Mono Pointe

CITY OF LAS VEGAS INTER-OFFICE MEMORANDUM		DATE: February 2, 2021
TO: Land Development Services Department of Building & Safety		FROM: Albert Sung, P.E. Flood Control Project Engineer Department of Public Works
SUBJECT:	Drainage Study for:	COPIES TO:
	Moro Pointe	Westwood Professional Services
Cross Streets:	SEC Desert Foothills Dr. & Red Pass Drive	Howard Hughes Company
File Number:	F:\Depot\DSMemos\DS5413A.doc	Bart Anderson, P.E., DevCo
Parcel Number:	137-23-410-003 & 137-26-112-004	CCRFCD
Zoning Action:	20-0196-TMP1	
FEMA Flood Zone	YES NO X	
Proposed Storm Drain	YES X NO

The Drainage Study for the subject project has been reviewed and:

SD LATERAL II - PLAN VIEW

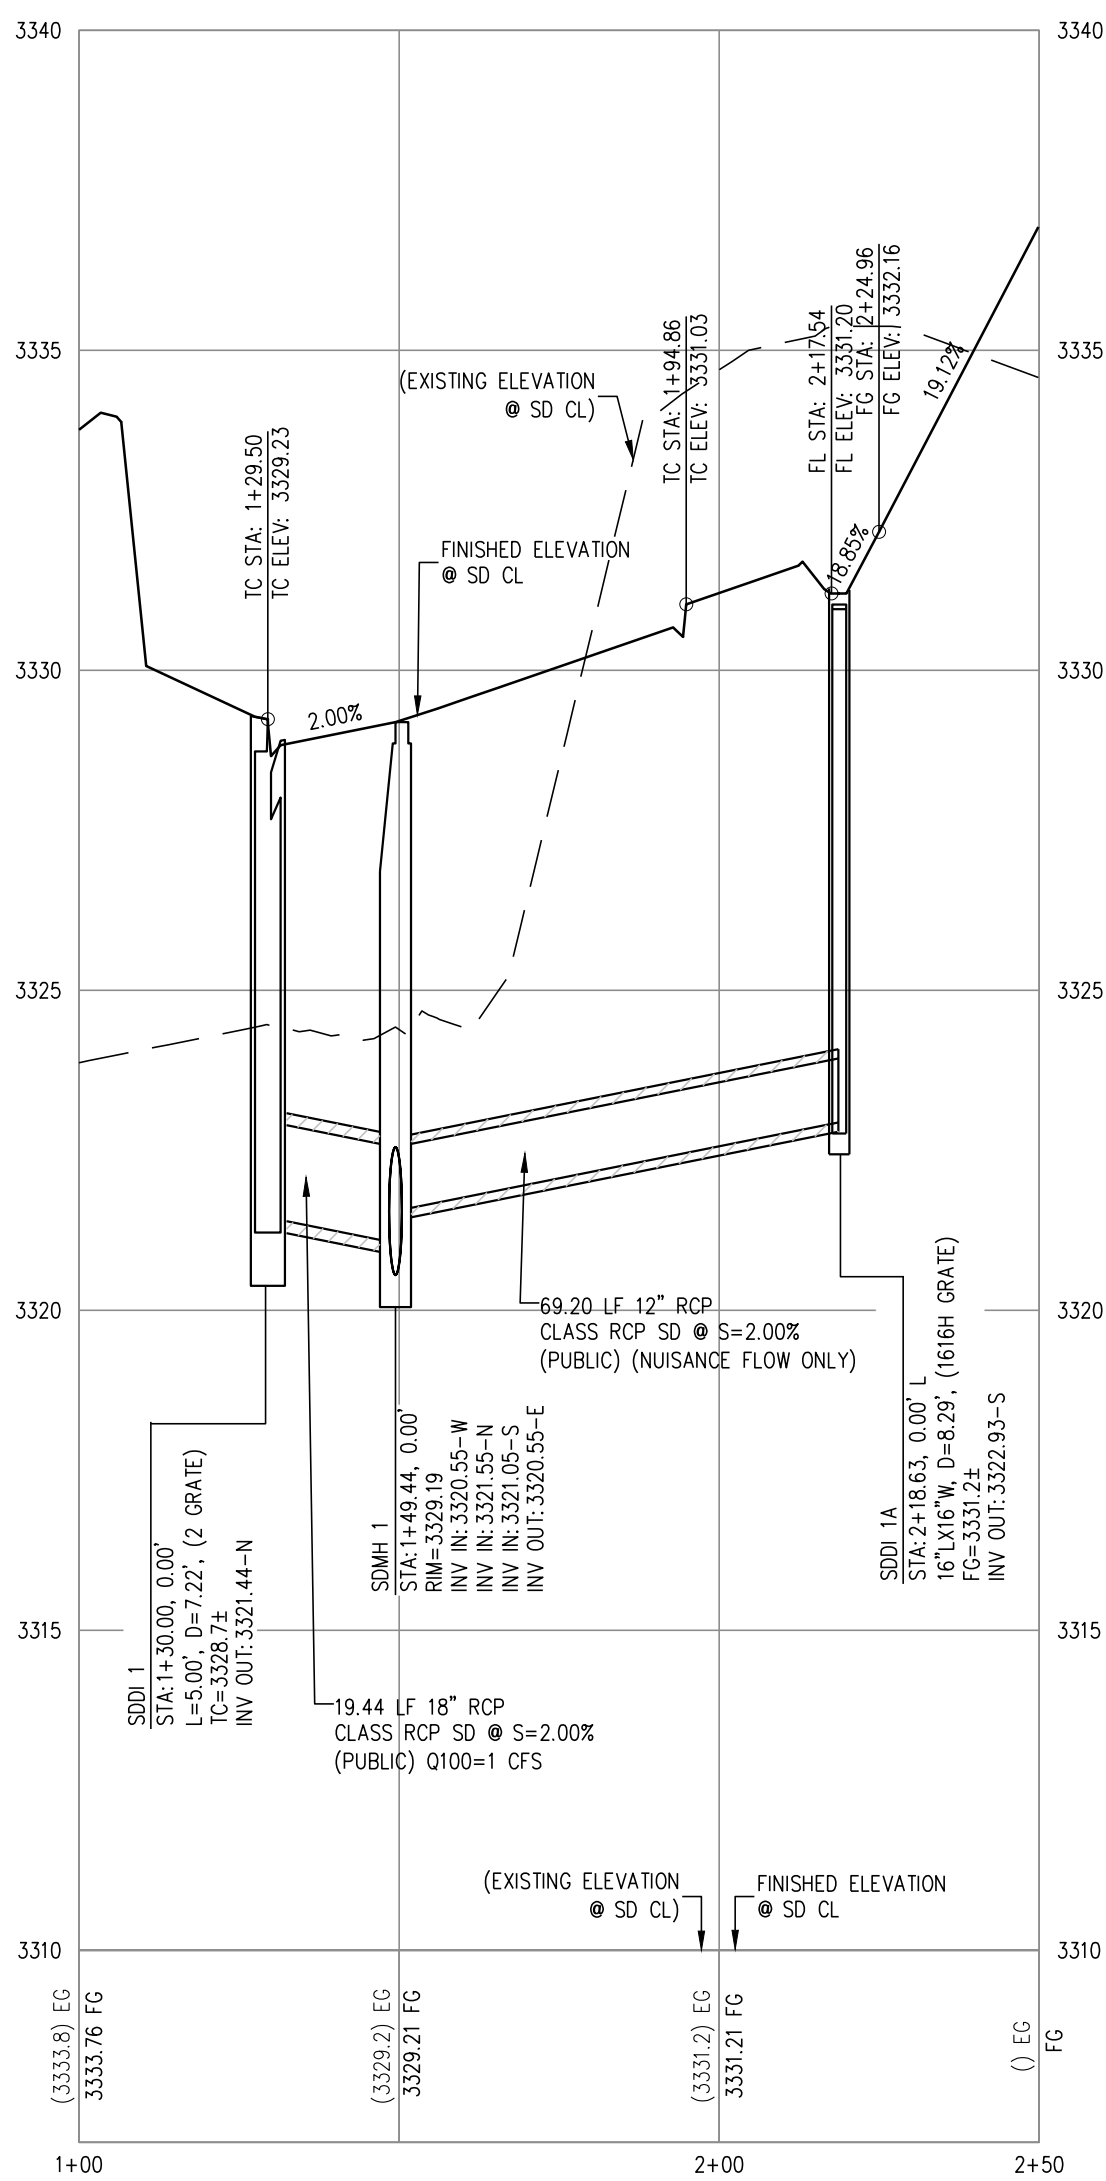
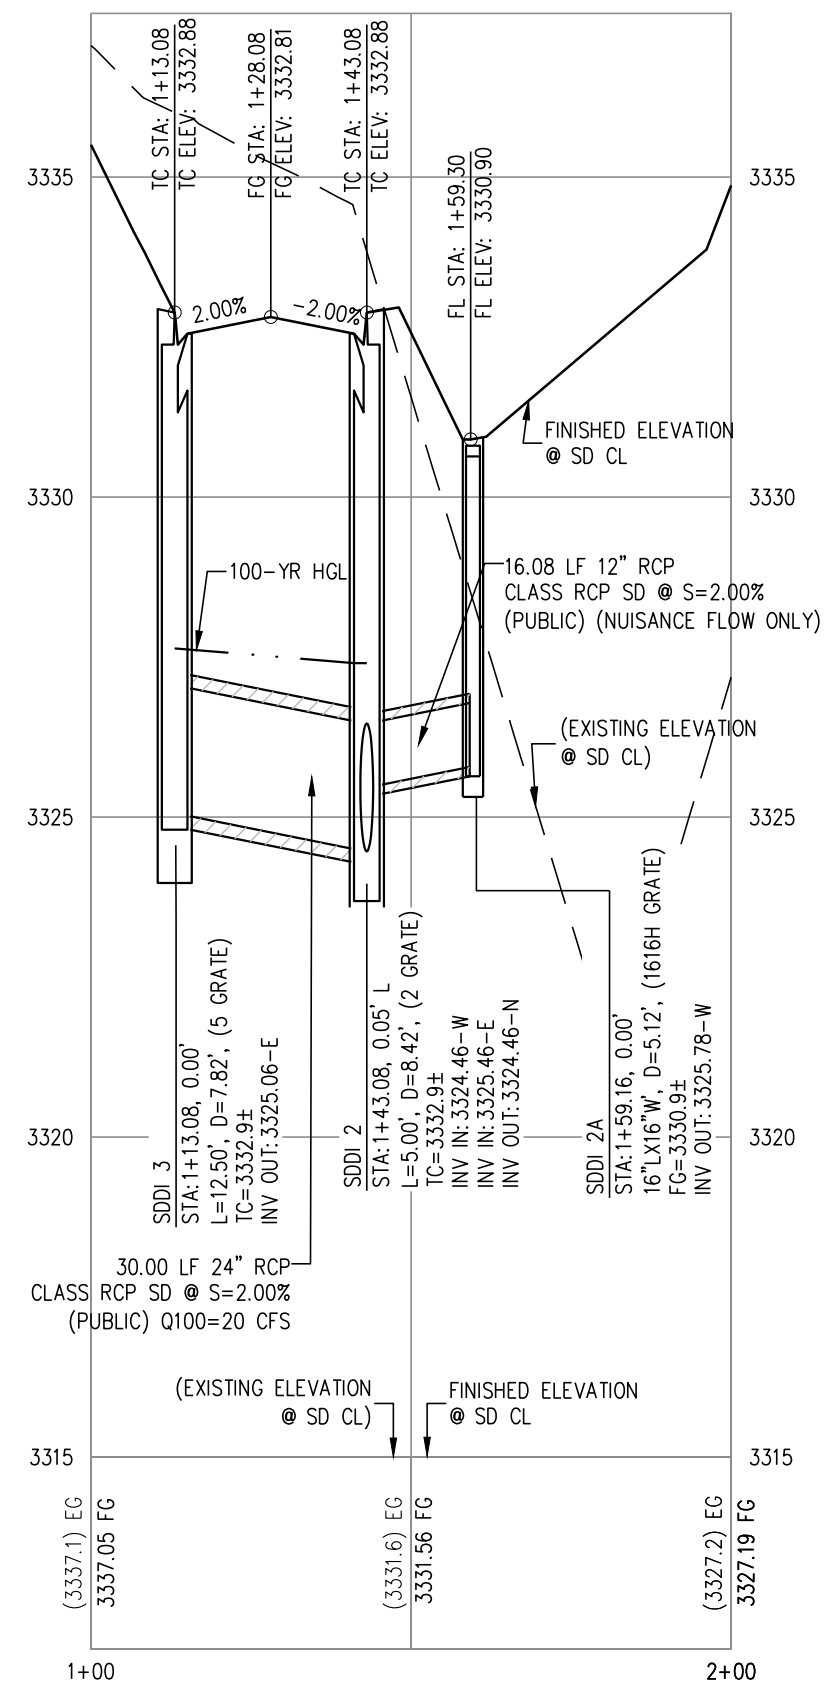
10. **Sheet PP-3**: Provide the 100-year HGL for SD Lateral I and SD Lateral II.
11. All drainage easements must be public drainage easements to be privately maintained to be labeled on the grading plans and to be dedicated as such in the final map.
